## Wood River Valley Modeling Technical Advisory Committee Response to Comments on Draft Modeling Objectives

Presented by Sean Vincent  
August 1, 2013

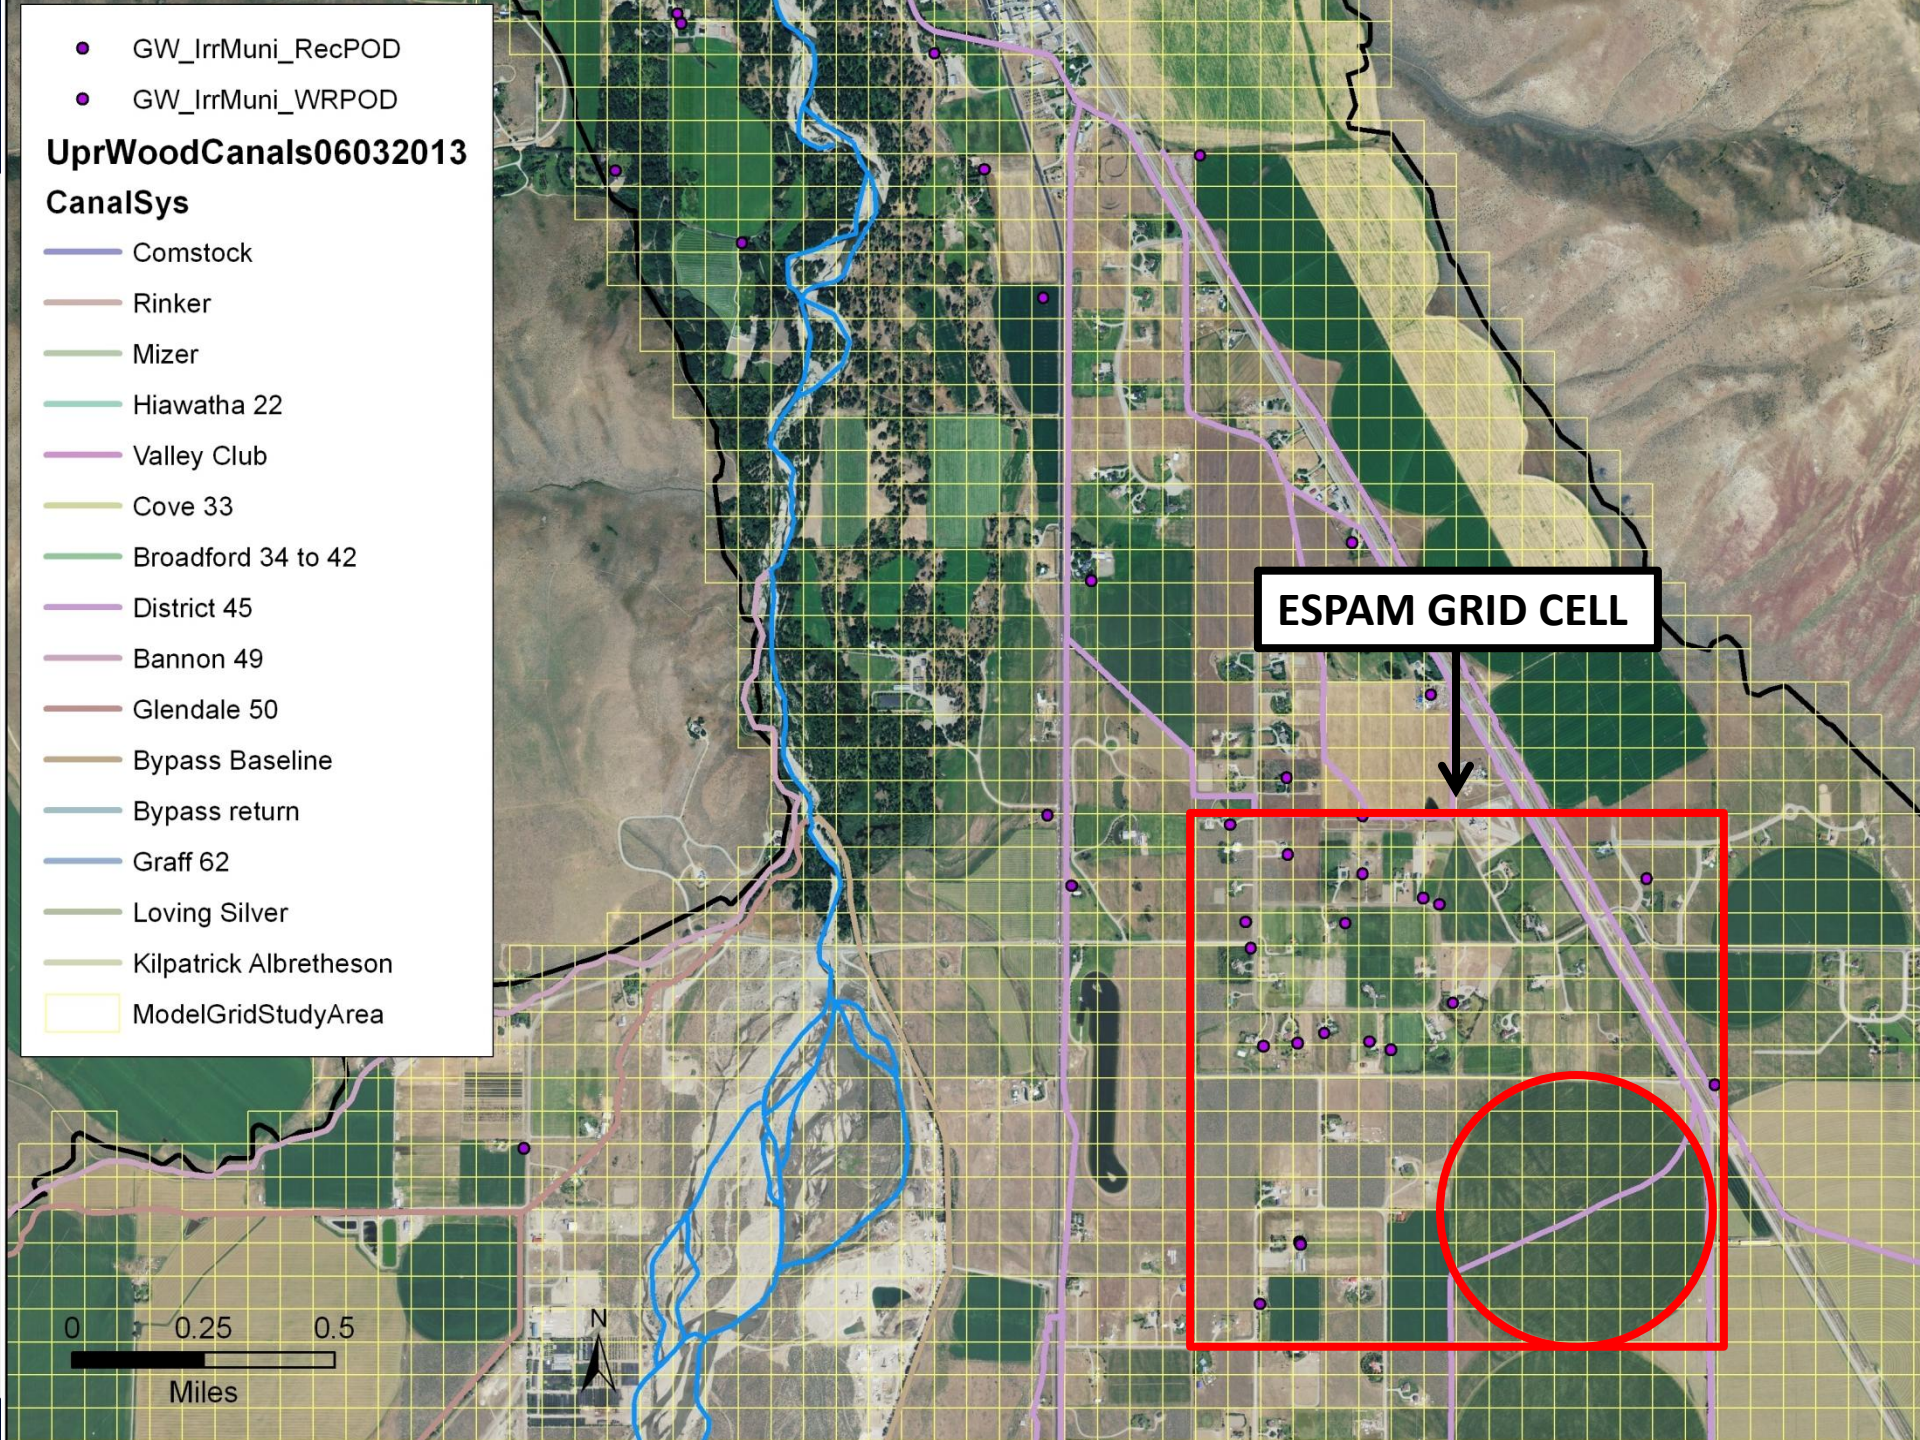
## Response to Comment #3 (too coarse)

- For 100m x 100m grid cells:
  - 23,600 cells intersect WRV study area (larger, 1-layer ESPAM has 11,236 active cells)
  - Center pivot ~ 8 grid cells wide
  - ~256 cells to cover the area of 1 ESPAM cell
- 100m grid spacing likely exceeds defensible level of refinement based on density of calibration data
- Local grid refinement relatively easy w/ MODFLOW USG
